THE UNIVERSITY OF TEXAS AT AUSTIN

Nuclear Engineering Teaching Laboratory • Austin, Texas 78758

Subject: Submission of Changes to License Technical Specifications

Ref: The University of Texas at Austin Facility License R-129, Docket 50-602

6.1.1 Structure

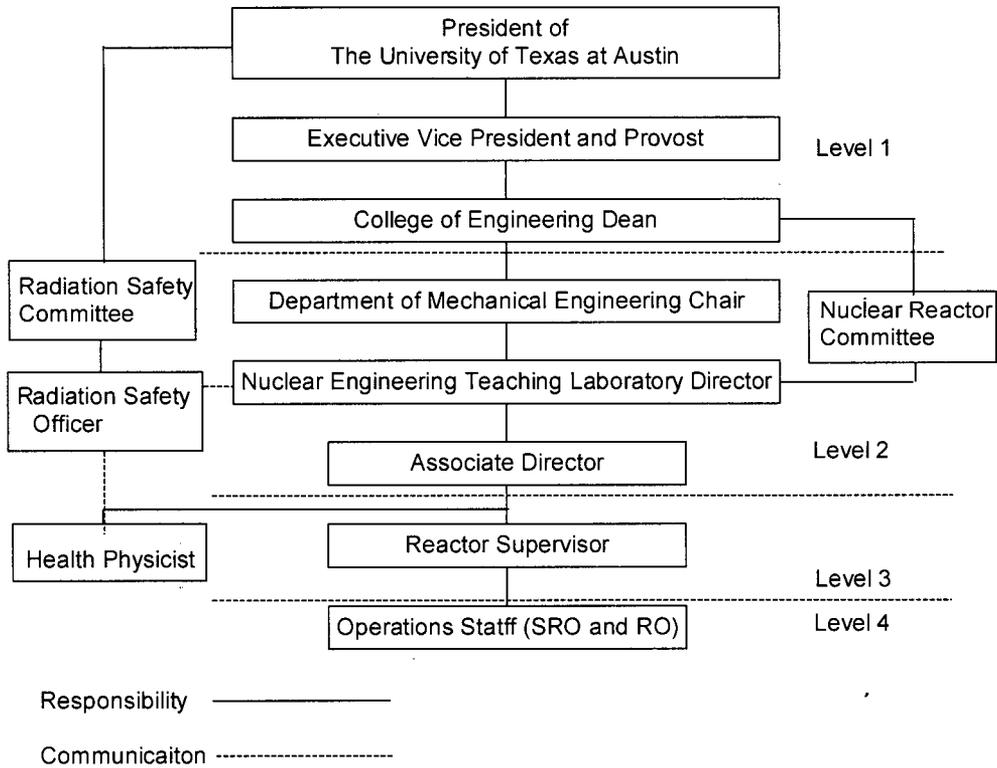
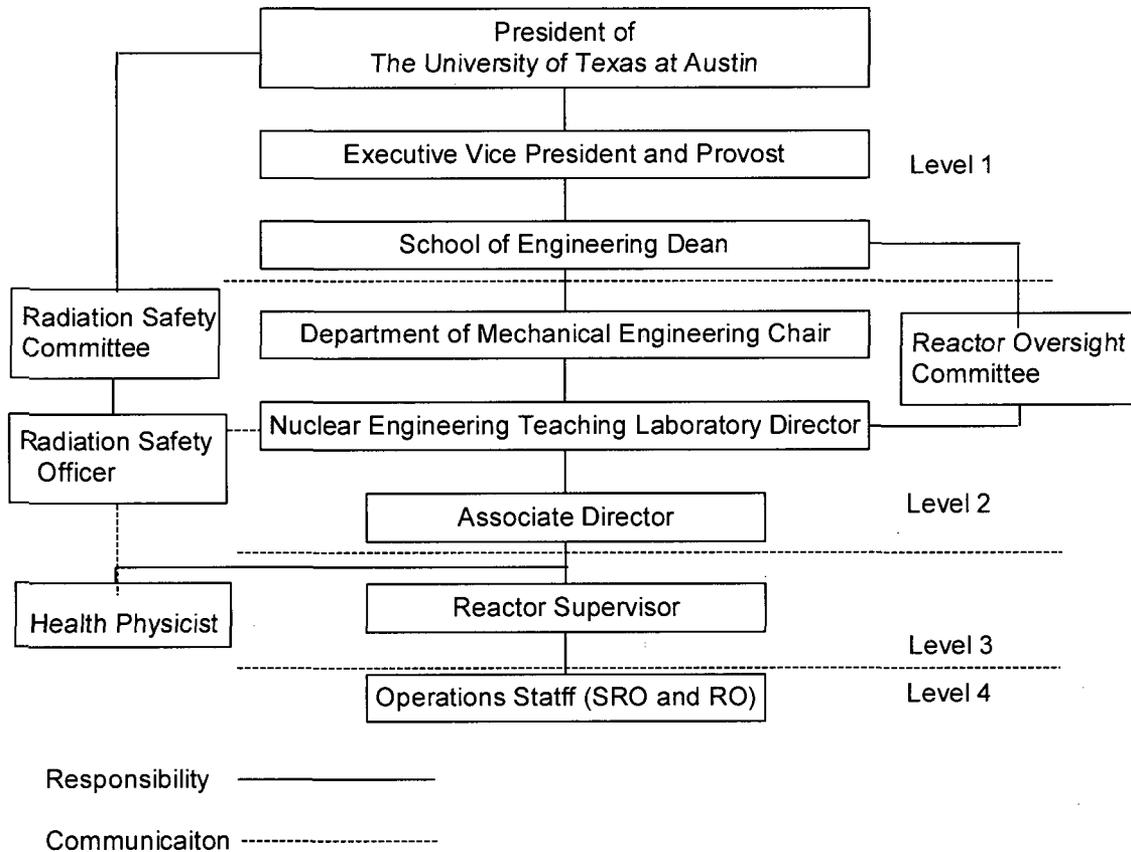
CHANGE 7

The name of the university safety review committee was changed from Nuclear Reactor Committee (NRC) in 2006 to Reactor Oversight Committee (ROC) to avoid confusion with the name of the U.S. Nuclear Regulatory Commission (NRC). The name of the College of Engineering was changed to the *School of Engineering* in 2007.
